SITING AND GRADING PLAN

Royal Pine Homes / Centerfield Properties Inc - 216102
"OAKRIDGE MEADOWS", RICHMOND HILL, ON

BLOCK 54

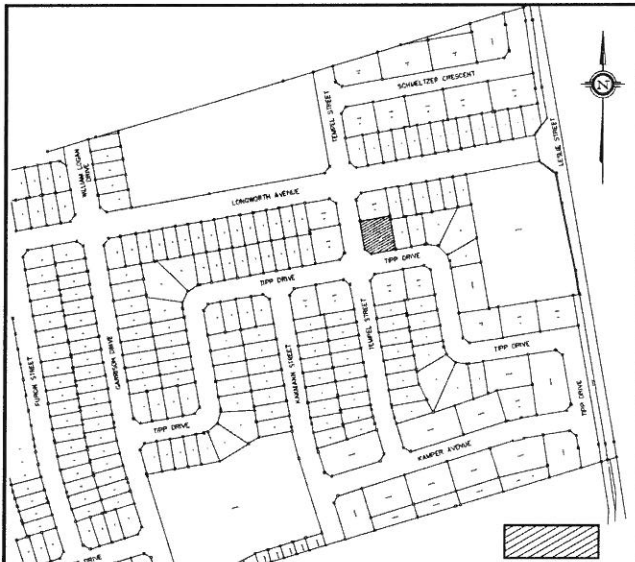
No unprotected openings permitted within 1.2 meters of the lot line as per article 9.10.14 of the Ontario Building Code.

As per OBC 2012, Div.B, 9.10.14.5(5), projections such as balconies, eaves, stairs, etc., that are more than 1m above grade, shall be non-combustible when within 1.2m of a property line or 2.4m of a combustible projection on another building on the same property.
